DEVELOPMENT REVIEW BOARD REPORT

**Mountain View
Shopping Center -
Exterior Remodel
22-DR-2023**

Request for approval of exterior building modifications to an existing shopping center, including the removal of the existing arcade and changes to roofing material and paint for a +/- 7.6-acre site.

Sheet No.: BUILDING C-D-E NEW ELEVATIONS

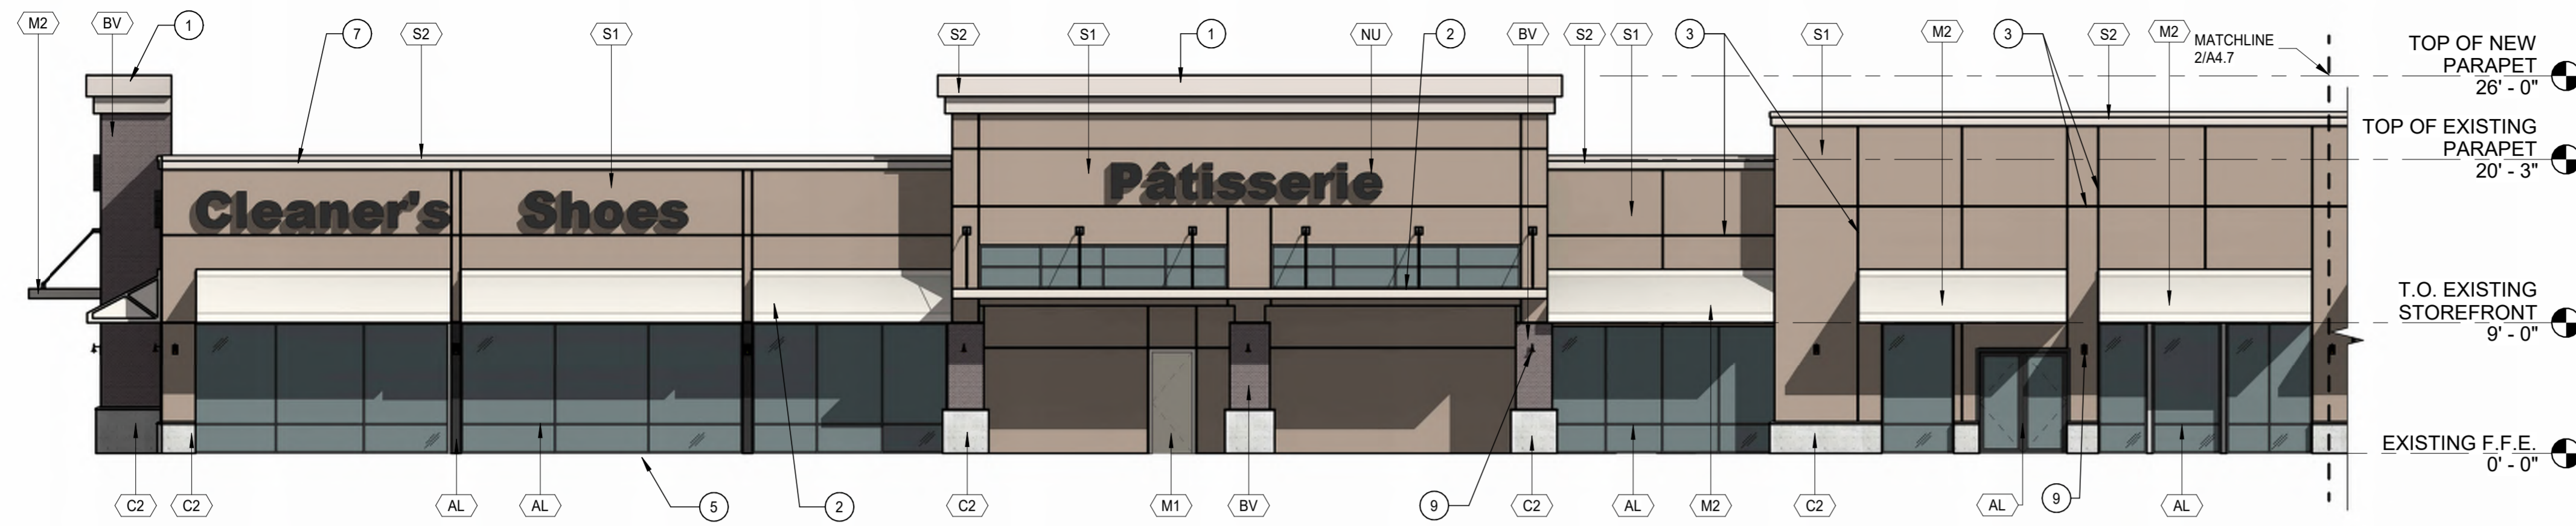
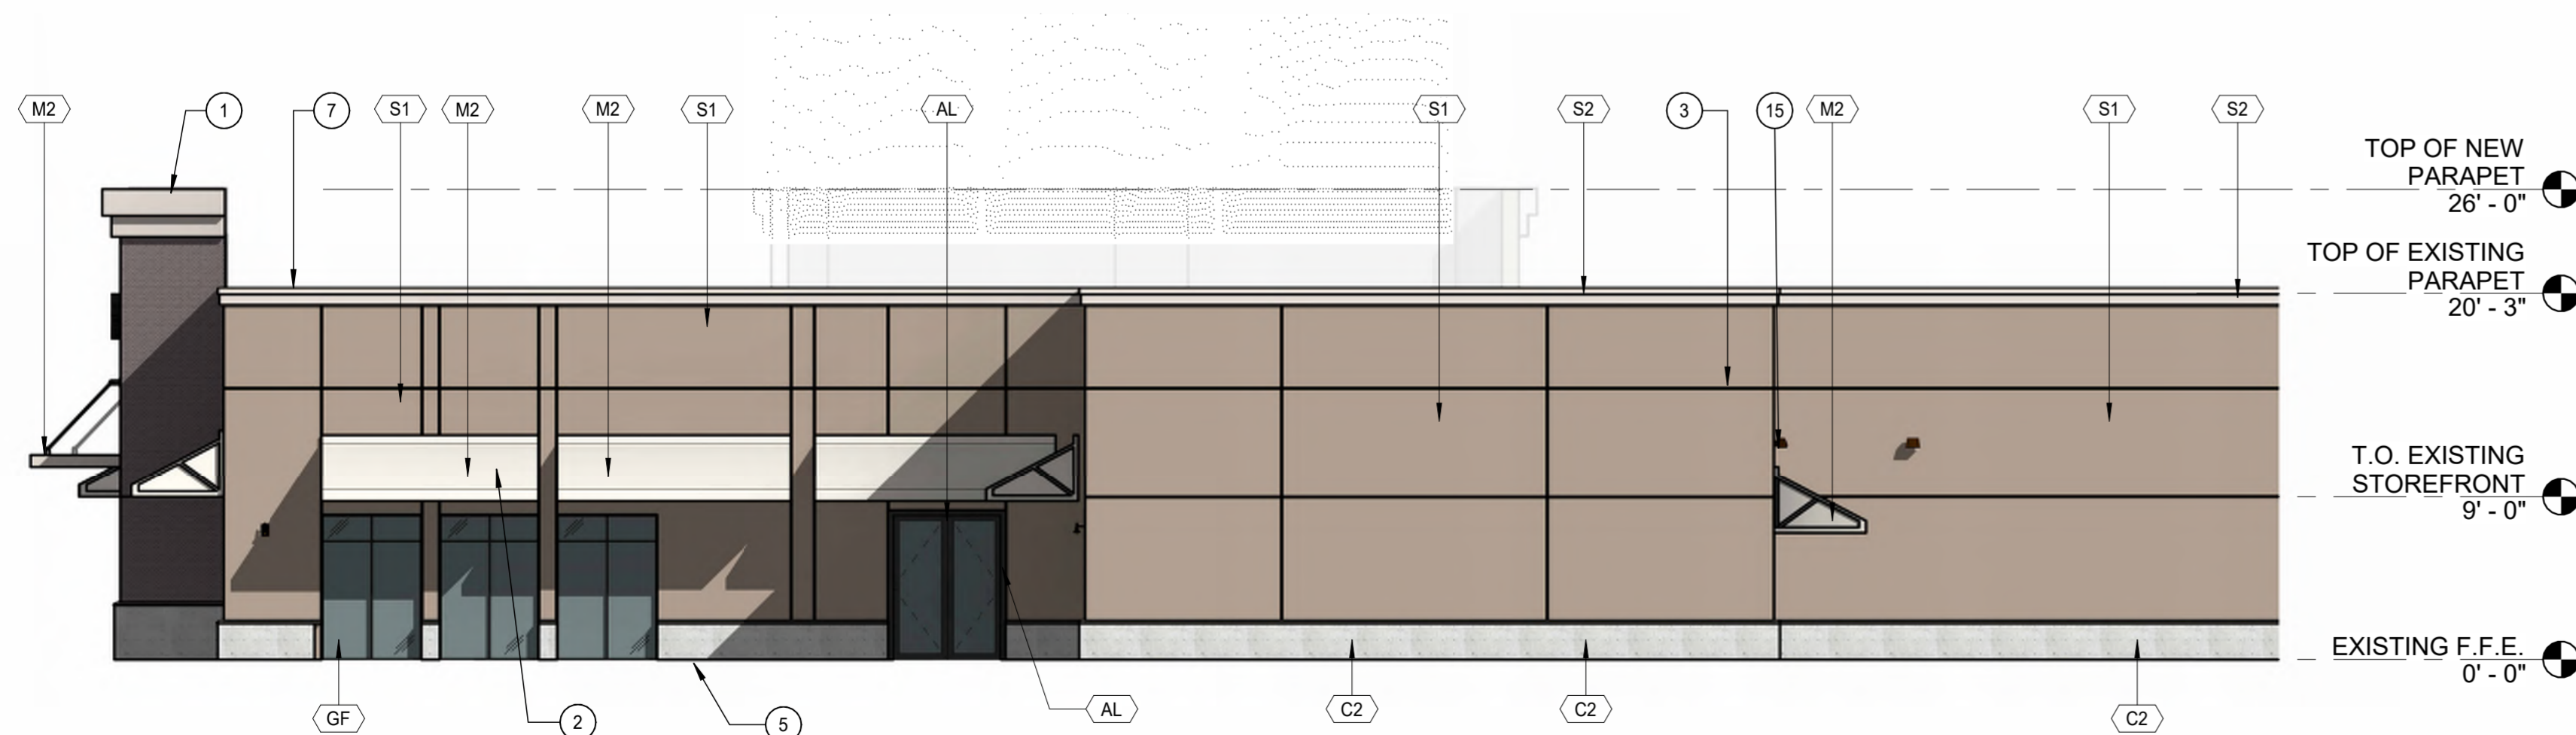
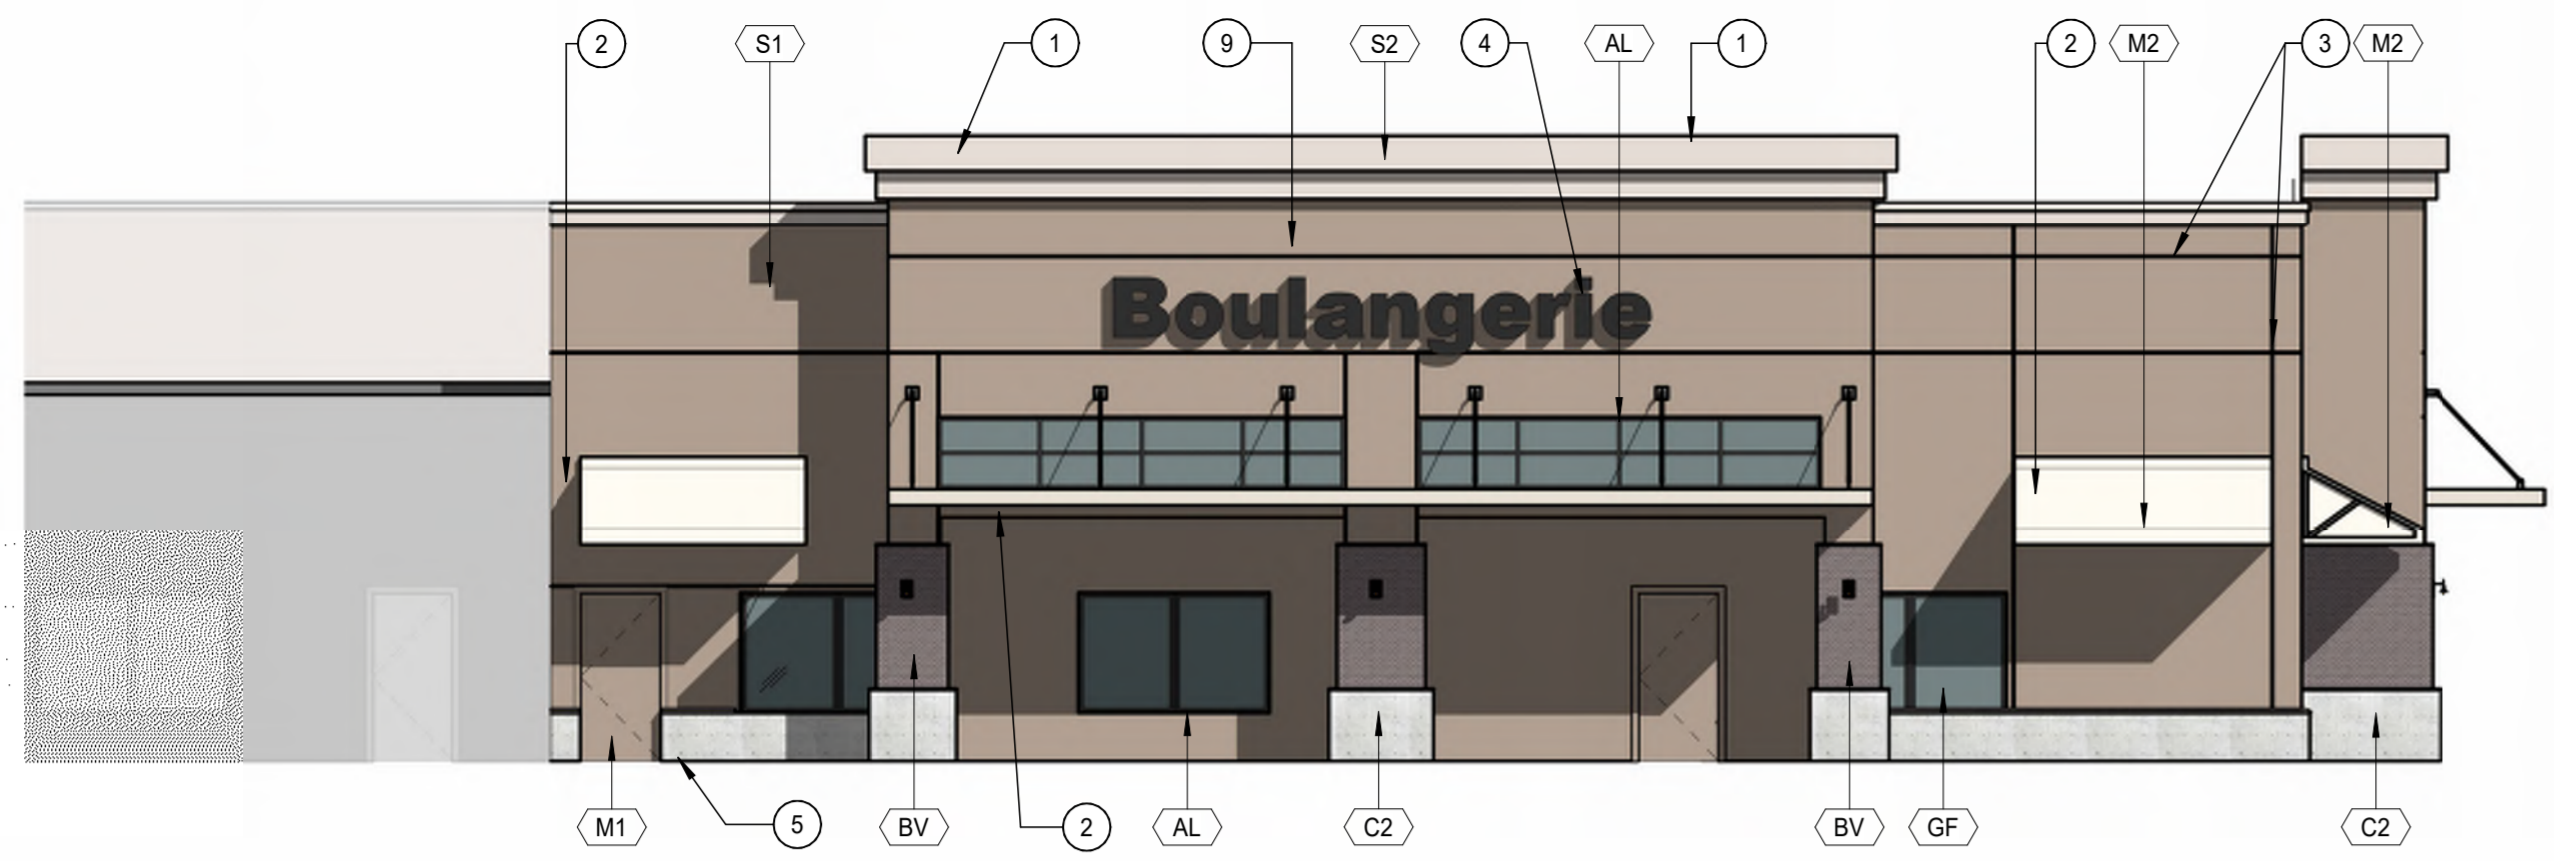
4. All new exterior doors that are not a part of the existing storefront system shall be recessed a minimum of thirty (30) percent of the wall depth, the amount of recess shall be measured from the face of the exterior wall to the face of the glazing, exclusive of external detailing. With the final plan submittal the developer shall provide head, jamb and sill details clearly showing the amount of recess for all door types.
5. The concrete wainscot shall be extended to completely wrap all columns.
6. At time of final plans, the applicant shall submit updated elevations of all building facades to updated call out C2 as it does not exist. It should be C1.
